BOARD OF WATER SUPPLY

Subject: Honolulu Board of Water Supply (BWS) Comments on the Red Hill Alternative Location Study, Red Hill Bulk Fuel Storage Facility (RHBFSF), Administrative Order on Consent (AOC) Statement of Work (SOW) Section 8.f, dated March 6, 2018

Figure 3.

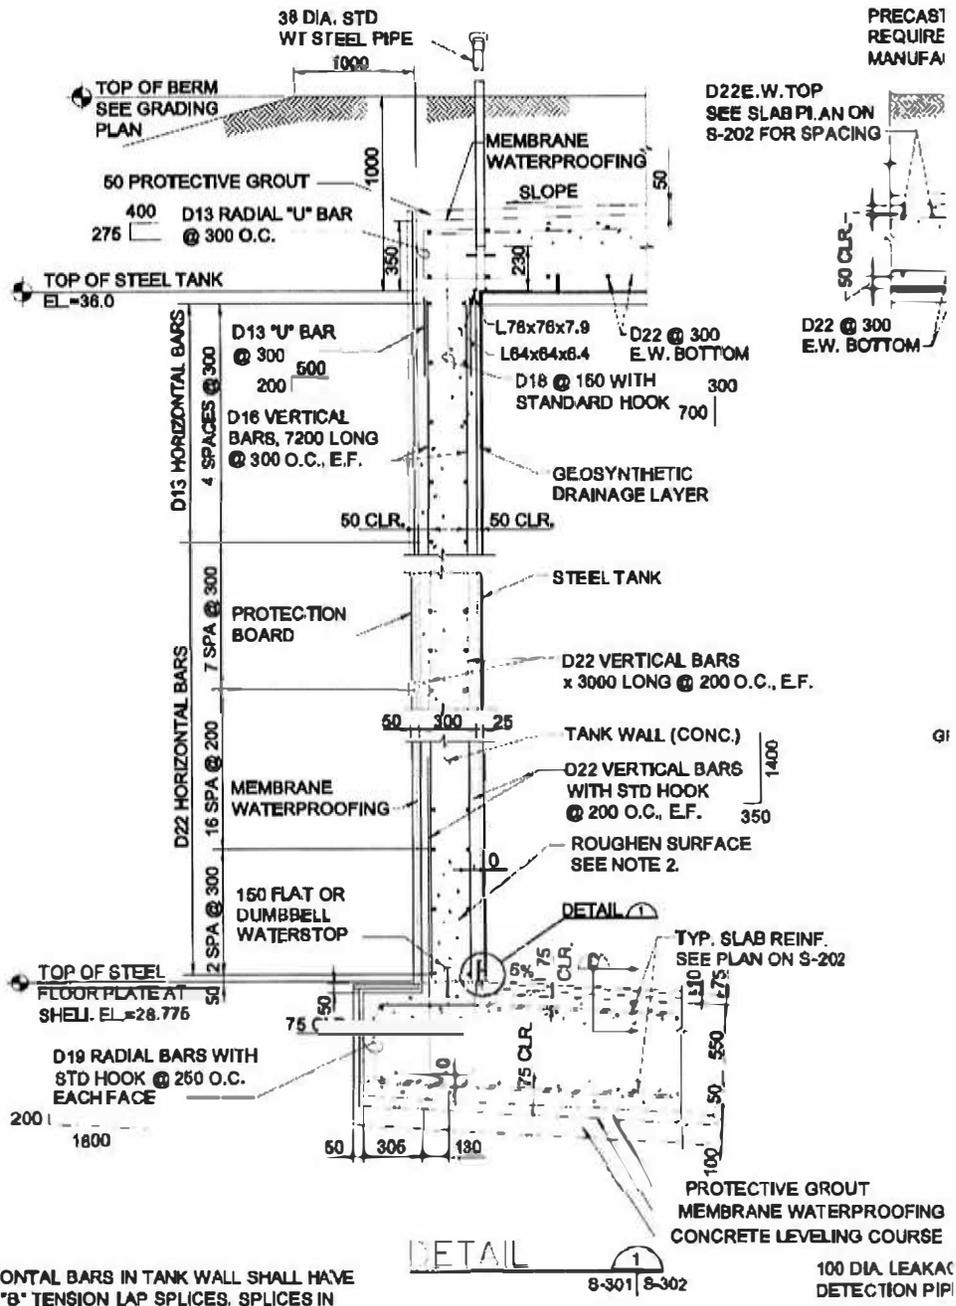
3. From our review of the referenced materials, it is unclear whether the geosynthetic drainage mat or the reinforced concrete wall is intended to be the secondary barrier (Figure 3). The drawings require the reinforced concrete be designed per ACI 318-05 (Figure 2), but the intent of those provisions is not waterproof construction, which requires special detailing and reinforcing. In addition, the drawings do not call for a watertight geosynthetic drainage layer membrane, nor are there provisions to protect it during construction (such as erecting a rebar cage immediately adjacent). The tank design should include explicit requirements for a reliable secondary containment barrier design capable of containing leaks into an interstice that allows continuous leak monitoring.

Cross section of tank wall depicted in Detail A of the referenced DoD Standard Design AW 78-24-33, Sheet 302, also showing concrete cast tight against drainage mat, precluding opportunity to coat the concrete.

Figure 4.

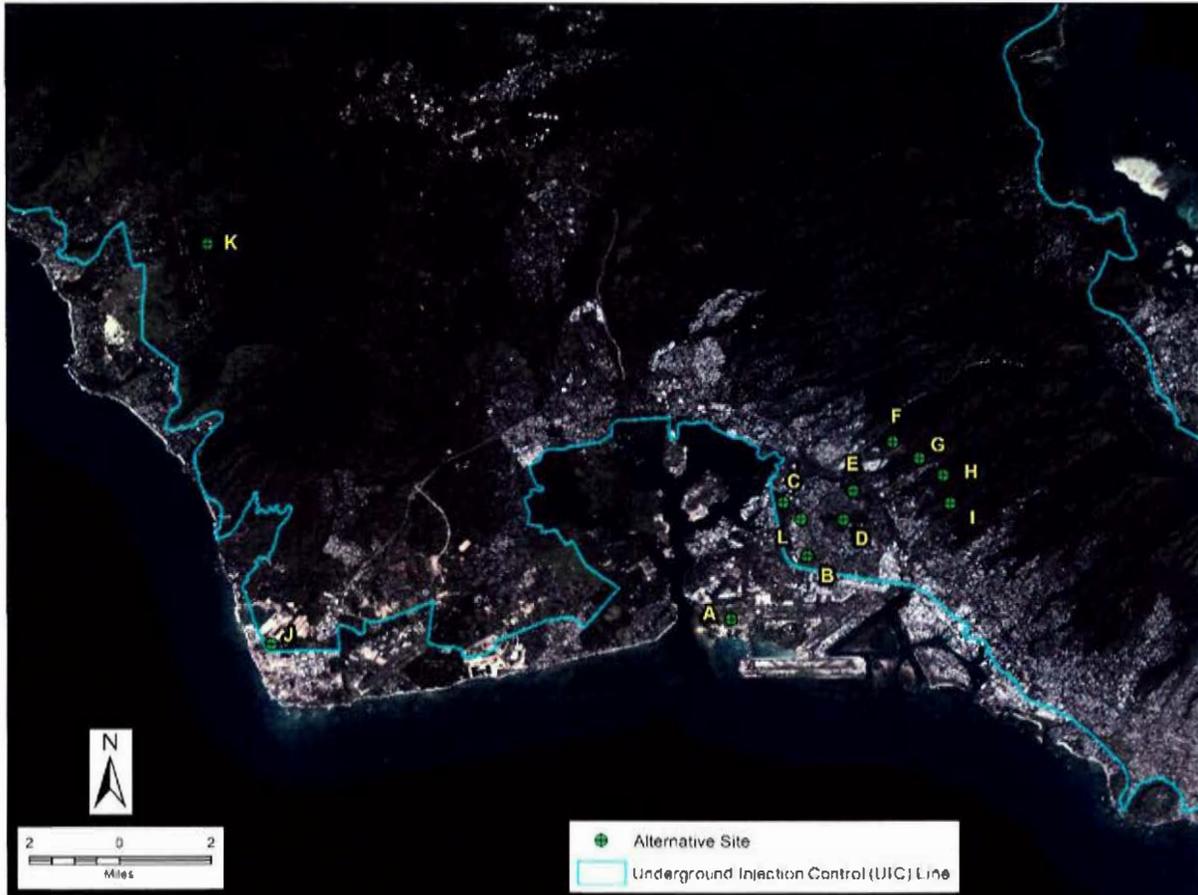
2. The Navy's selection factor "Proximity to Drinking Water Wells" incorrectly implies that contamination potential scales with distance to a drinking water source by ignoring whether the site is located upgradient or downgradient (relative to the regional groundwater flow direction) of the water supply. Sites that are upgradient of water supplies pose a much larger risk than sites that are downgradient of the water supplies. All but one of the alternative sites considered lie inside the Hawaii Department of Health's Underground Injection Control (UIC) line (see Figure 4), which indicates that all but one have the potential to contaminate O'ahu drinking water. Only Site A is located outside the UIC line shown in Figure 4. Releases at sites proximate to the UIC line have less potential to contaminate the drinking water than those further inland and hydraulically upgradient.

Locations of alternate sites scored in the Navy relocation report. Cyan line indicates the underground injection control line, which is adapted from DOH webserver (<http://histategis.maps.arcgis.com/apps/Viewer/index.html?appid=4261e15895cc46fd82cd5e8e396fdf63>) on April 30, 2018.

Figure 5.

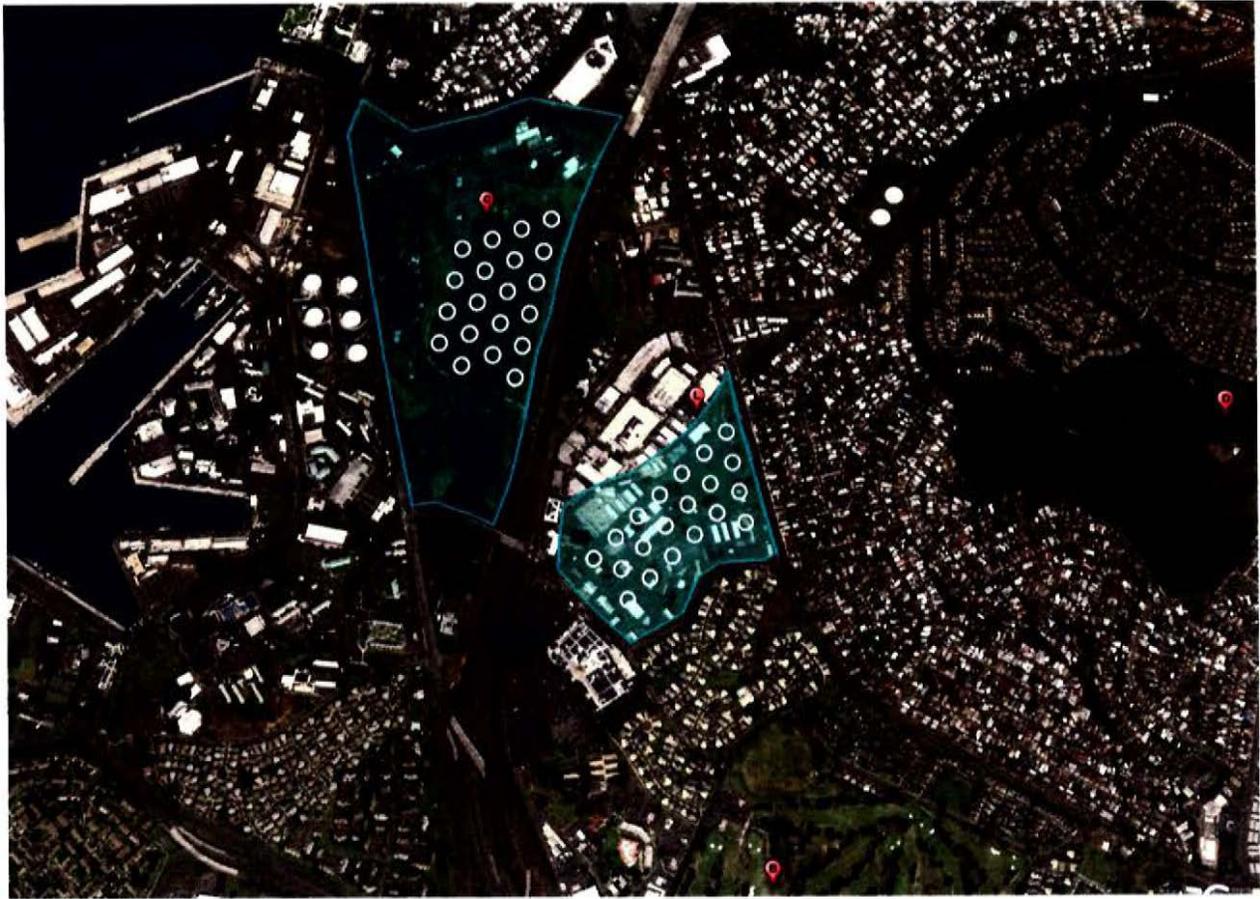
3. Requiring that all tanks be located within a single site unnecessarily restricts relocation alternatives. For instance, Sites C and L could be combined into a single alternative (Site C+L).

The BWS believes that the flaws inherent to the Navy's site selection methodology materially impacted the ultimate site identified by the Navy as the "best choice" for tank alternative locations. Upon further consideration of the concerns listed above, it becomes clear that other tank alternative location options may be preferable. For example, consider a new alternative location comprising Site C (Makalapa Crater Military Housing Area) and Site L (NAVFAC Hawaii Facilities) together. Most importantly, this composite Site C + L lies close to the UIC line (Figure 4), and thus any spills or leaks at this site would pose little risk to the aquifer compared to Site G (Kapūkaki) located near the RHBFSF. The tanks spaced as described in the relocation alternative report would fit within this composite Site C+L; an example layout is shown in Figure 5.

BWS Composite Site C+L (approximated by blue shading) showing one possible tank layout.
